Subject: Original Biologics License Application (BLA) STN 125742/0 Review

Memorandum – BioNTech Manufacturing GmbH in partnership with Pfizer,

Inc.: to provide for review of the responses to the 483 Inspectional

Observations issued during the July 19 – 23, 2021, Pre-License Inspection

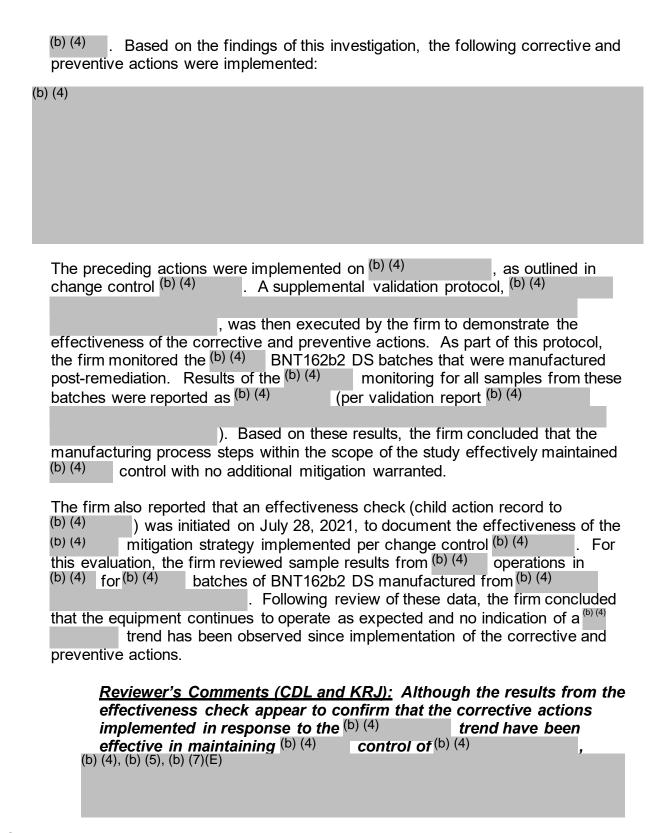
Observation No. 4 (written by KRJ)

4. Per (b) (4)

validation has not been performed on the (b) (4)

(b) (4)). The (b) (4) is stored in a (b) (4) and as a result, a

(b) (4) trend occurred in (b) (4) (b) (4)); noted by identification of

between manufacturing batches. Consequently, the opportunity to collect (b) (4) samples for (b) (4) is limited. The firm also noted that the ability to collect (b) (4)

from the surface of the (b) (4) (b) (4) is impractical as the (b) (4) would need to be dismantled. As a result, the (b) (4) system is subject to cleaning verification via in-process monitoring rather than the cleaning cycle being validated (via execution of a cleaning performance qualification protocol).

The firm confirmed that $^{(b)}$ (4) is subject to routine process monitoring controls which ensure, among other things, detection of $^{(b)}$ (4) . The $^{(b)}$ (4) trend referenced in the observation was detected with these controls and subsequently evaluated as part of investigation $^{(b)}$ (4) (initiated on $^{(b)}$ (4)). The investigation determined that the most probable root cause for the $^{(b)}$ (4) trend was certain areas of the $^{(b)}$ (4) not being $^{(b)}$ (4) . The root cause for the inadequate $^{(b)}$ (4) of the $^{(b)}$ (4) was identified as an $^{(b)}$ (4) , which resulted in a

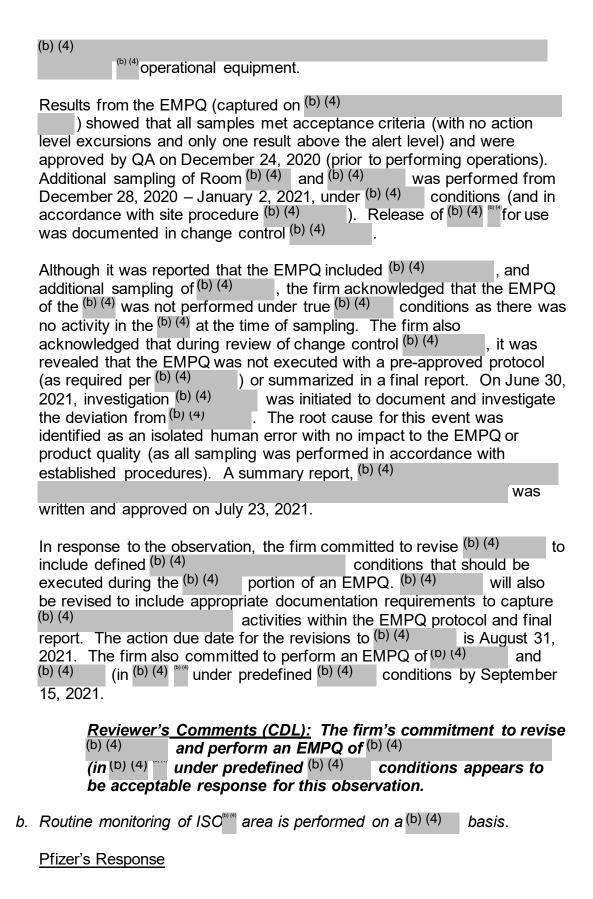
Observation No. 8 (written by KRJ)

8.	Routine monitoring of adequately represent	the compressed all points of use listed in ^{(b}	e. Only ^(b) (4	ding (b) (4) (b) (4) (b) (4)	does not , specifically ^{(b) (c}	4)	
					are routinely	,	
	monitored.						
	Pfizer's Response						
	The firm's response noted that at the present time, no specific regulatory guidance documents (or requirements) exist regarding the number of compressed air points of use (POUs) to be sampled or the frequency of sampling. However, the firm did reference recommendations such as the ISPE Good Practice Guide, which recommends testing every (b) (4) on a rotating basis from representative sample locations.						
	The firm also indicate	d that ^{(b) (4)}					
	program for the compa	were designate	ed as repre	of this prog	ample locations v

Results from routine monitoring of b (a) showed that all samples met b (b) (4) quality levels for the period from March 7, 2019 – May 7, 2021. Based on these results, the firm concluded that the compressed air system in Building (b) (4) is operating in a state of control (based on only sample locations); however, they also acknowledged that (b) (4) will be revised to include a requirement that all (b) (4) locations be tested each (b) (4) The due date for this action item is August 31, 2021. Relevant individuals will also be trained in accordance with site procedures.

Reviewer's Comments (CDL): The firm's commitment to revise (b) (4) to include a requirement for (b) (4) sampling of all (b) (4) is considered an acceptable response for enhancement of their monitoring program.

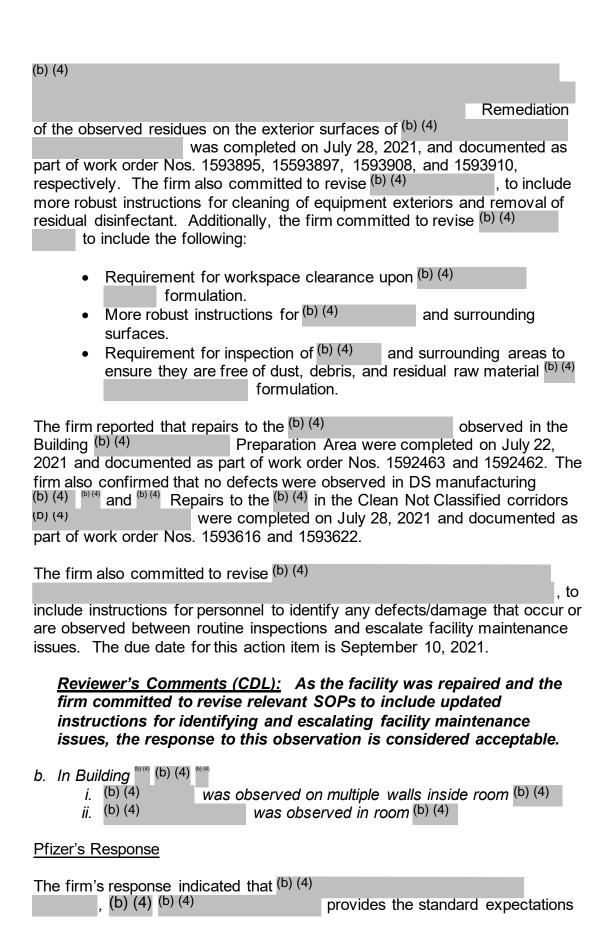
- a. In Building (b) (4) preparation area:

i. (b) (4) was observed on multiple walls.

ii. (b) (4) was observed in the hallway.

iii. (b) (4) were observed with dust and debris on the (b) (4) and streaking/raised residue down the sides and bottom of multiple (b) (4).
- Pfizer's Response

provides standard expectations for quarterly self-inspections of the external condition of the equipment, general physical appearance inside manufacturing spaces, and associated mechanical spaces. According to the firm, the last self-inspection of ^(b) (4) was performed on June 7, 2021, and documented in report ^(b) (4)

for (b) (4) self-inspections that are required to ensure that issues are escalated and resolved when observed. According to the firm, the last self-inspection of (b) (4) was performed on July 14, 2021 and documented as part of work order No. 1528780. The firm claimed that Operations personnel are performing self-inspections as required per (b) (4)

The firm confirmed that repair of the (b) (4) (b) (4) (b) (4) (b) (4) (b) (4) (5) (4

<u>Reviewer's Comments (CDL):</u> As the facility was repaired and the firm committed to revise (b) (4) to include updated responsibilities for escalating facility/equipment issues, the response to this observation is considered acceptable.

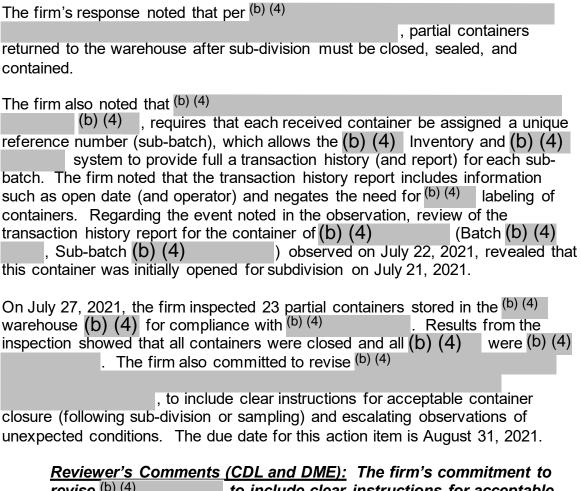
d. A gap to the outside was observed on the side of the mobile platform at the receiving dock in Building

The firm confirmed that the gap identified on the loading dock door at location (b) (4) was repaired on July 23, 2021 and documented as part of work order No. 1591632. The firm also committed to revise (b) (4) to include addition of a step in Section 5.11 (Pest Control Device Inspections and Locations) that requires the pest control provider to inspect doors and similar openings for adverse conditions that could lead to pest infiltration. All adverse conditions will continue to be documented in the pest control report. Additionally, the Pest Control Specialist or designee will continue to initiate work orders to address any deficiencies. The due date for revision of (b) (4) is August 31, 2021.

Reviewer's Comments (CDL): As the dock door was repaired and the firm committed to revise (b) (4) to include addition of a step for inspection of doors (and other openings), the response to this observation is considered acceptable.
